Technical Service Bulletin

SUBJECT:		No: TSB-23-23-001	
CVT BELT CHECK – SERVICE MANUAL REVISION		DATE: January 2023	
		MODEL: See below	
CIRCULATE TO:	<input type="checkbox"/> GENERAL MANAGER	<input checked="" type="checkbox"/> PARTS MANAGER	<input checked="" type="checkbox"/> TECHNICIAN
<input checked="" type="checkbox"/> SERVICE ADVISOR	<input checked="" type="checkbox"/> SERVICE MANAGER	<input checked="" type="checkbox"/> WARRANTY PROCESSOR	<input type="checkbox"/> SALES MANAGER

This TSB provides the addition of Diagnostic Procedure for CVT Belt Check for vehicles equipped with CVT type F1CJC and W1CJC.

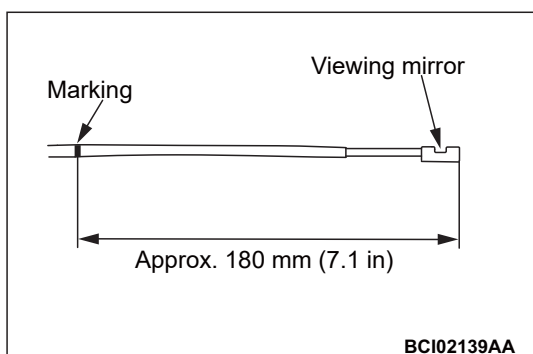
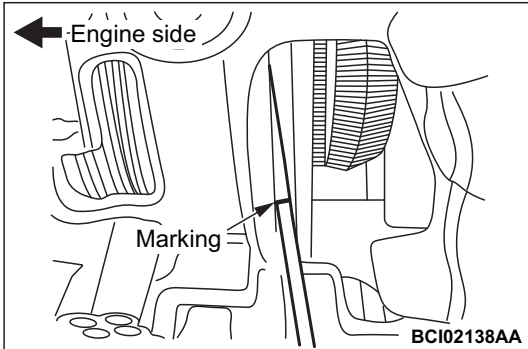
- (1) With the 90 degree viewing mirror, which is provided with the special tool bore scope (MQ600069), attached to the special tool bore scope (MQ600069), put a mark on the position shown in the figure.

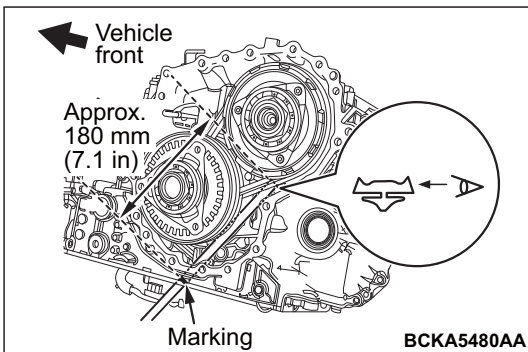
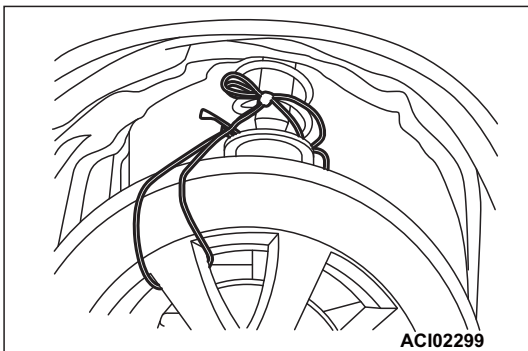
- (2) Insert the special tool bore scope (MQ600069) into the Transaxle case from the position shown in the figure until the mark [approximately 180 mm (7.1 inches)] on the special tool bore scope comes to the end of the Transaxle case, while making sure that the 90 degree viewing mirror is facing toward the left side of the vehicle.

- (3) Adjust the position of the 90 degree viewing mirror of the special tool bore scope (MQ600069) so that the side face of the belt element (the right side of the vehicle) can be seen.
- (4) Make a mark on a side wall of the front left tire to recognize one round of rotation.

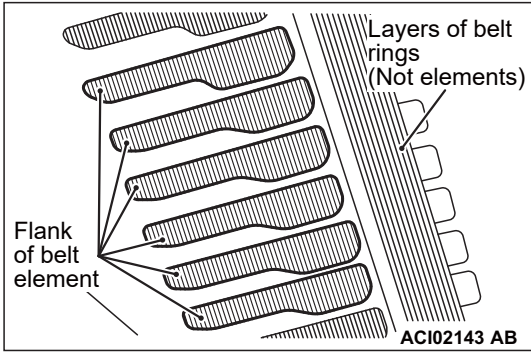
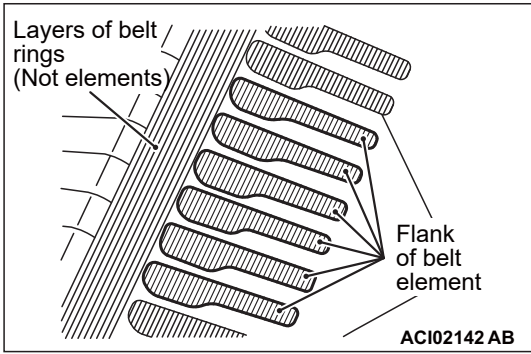
- (5) Slowly rotate the front left tire entire one round to rotate the belt to inspect all around of the belt element flanks surfaces.

NOTE: Rotate the tire as slow as each belt element flank can be carefully inspected if any evidence of damage presented or not, or pose the rotation periodically such as every 9 - 10 elements movement on a camera view, and inspect, and then move to next 9 - 10 elements to inspect.

<DAMAGE SAMPLES>

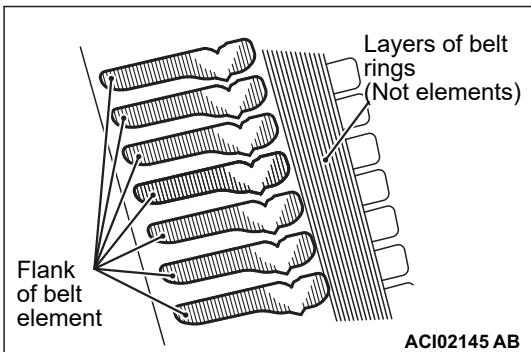
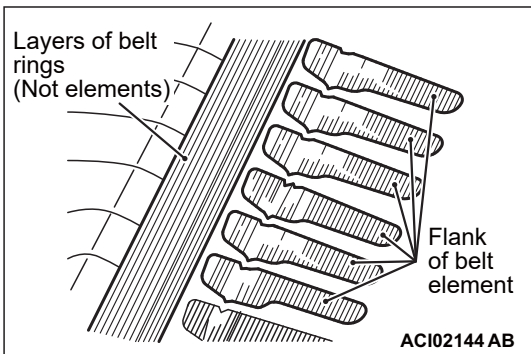
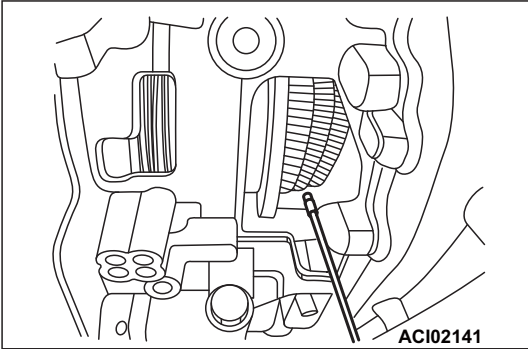
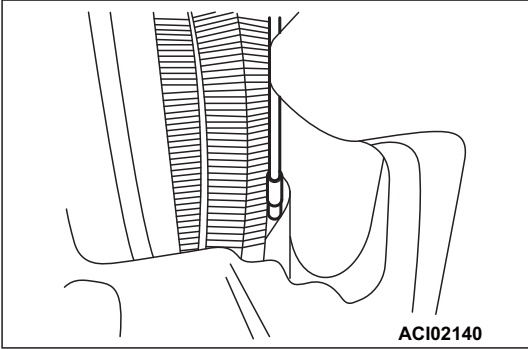
8. Refer to the OK samples and the damage samples below to determine the condition of the flanks (grooved surfaces) of belt elements. When a damage is found on the flanks of the belt elements, replace the CVT assembly (Refer to GROUP 23A - Transaxle assembly).

- Damages to grooves are observed on flanks of belt elements.

10. When a damage is found on the flanks of the belt elements, replace the CVT assembly (Refer to GROUP 23A - Transaxle assembly). When there is no problem, the inspection is complete.
